ALERT SERVICE BULLETIN

Exchange of turbocharger/exhaust clamps on ROTAX® Engine Type 915 i (Series) and 916 i (Series)

ATA System: 78-10-00 Exhaust system

Exchange of turbocharger/exhaust clamps on ROTAX® Engine Type 915 i (Series) and 916 i (Series).

Fig. 1

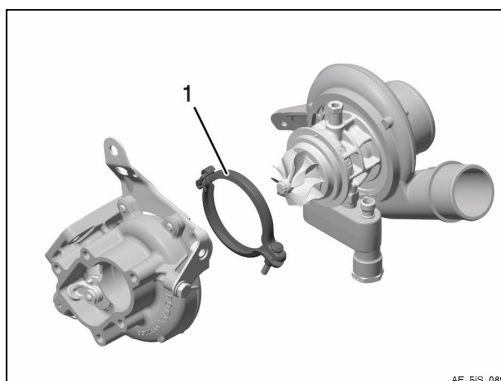
Due to a deviation in the machining process of the clamps, the affected batch may have developed cracks. This could lead to a clamp fracture or loosening, and subsequent exhaust gas leakage of turbocharger or exhaust muffler.

| Part no. | Qty/ engine | Description | Application |
|----------|----------------|-------------------|-----------------------------------|
| 651873 | 1 | clamp assy. 83 mm | Turbocharger hot section |

Fig. 2

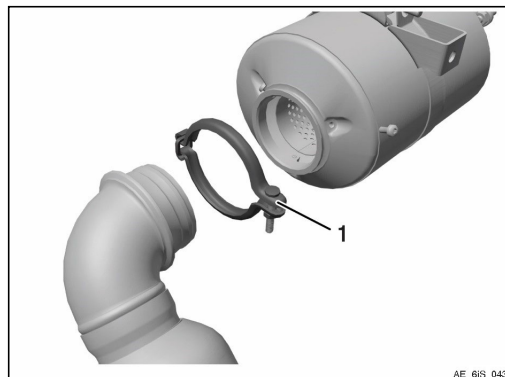
| Part no. | Qty/ engine | Description | Application |
|----------|----------------|-------------------|-----------------------------------|
| 651873 | 1 | clamp assy. 83 mm | Exhaust elbow (916 i Series only) |

Fig. 3

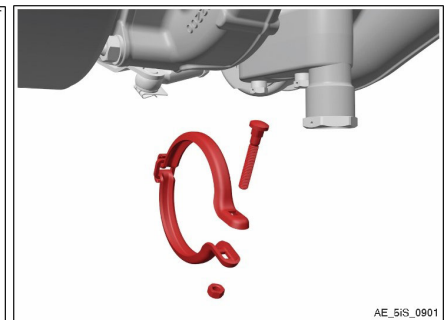
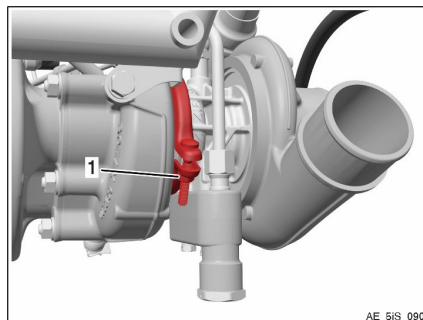
| Step | Procedure |
|------|---|
| 1 | Loosen Hex. nut M8 (1) from turbocharger clamp. NOTE: Support the turbocharger center housing and cold section. |
| 2 | Remove the clamp. |

Fig. 4
Turbocharger clamp assy.

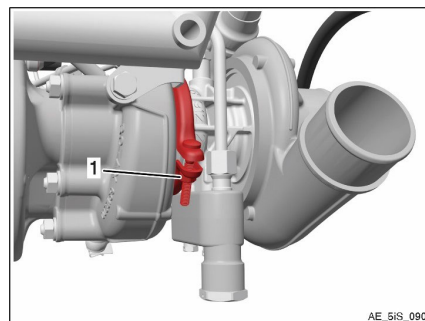
| Step | Procedure |
|------|--|
| 1 | Hold the turbocharger center housing and cold section in position on the hot section. |
| 2 | Place clamp into position between center housing and hot section, in the orientation depicted. |
| 3 | Hand tighten the clamp Hex. nut M8 (1). Check the alignment of center housing and hot section. Tighten clamp Hex. nut M8. Tightening torque 8 Nm (70 in. lb). |

Fig. 5
Exhaust elbow

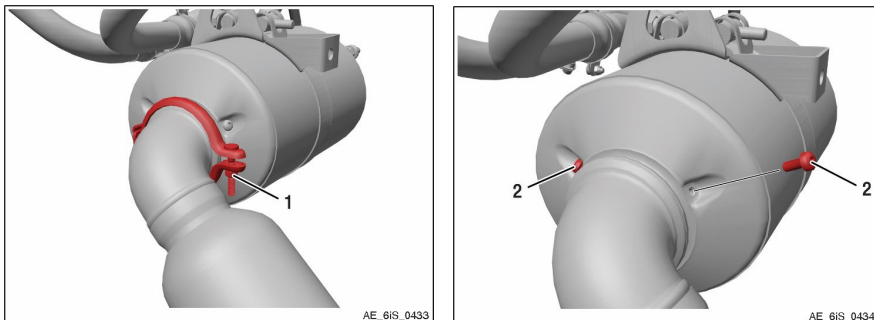
916 i (Series) engines use the same clamp assy. part no. 651873 for the attachment of exhaust elbow.

| Step | Procedure |
|------|--|
| 1 | Loosen M8 Hex. nut (1) from exhaust elbow clamp. NOTE: The exhaust elbow is held in position by 3 screw M5x12 (2). See current Maintenance Manual Heavy (MMH) for the respective engine type, Chapters 78-00-00, 78-10-00 and Chapter 78-20-00. |
| 2 | Remove the clamp. |

Fig. 6
Exhaust elbow clamp assy.

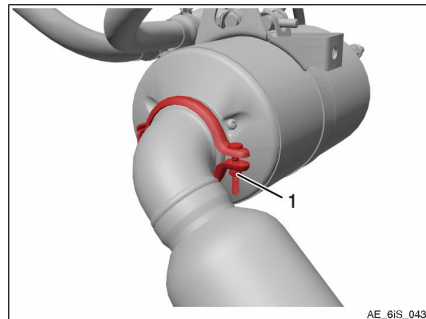
| Step | Procedure |
|------|---|
| 1 | Place clamp into position between the exhaust muffler and exhaust elbow, in the orientation depicted. |
| 2 | Tighten clamp Hex. nut M8. Tightening torque 8 Nm (70 in. lb). |
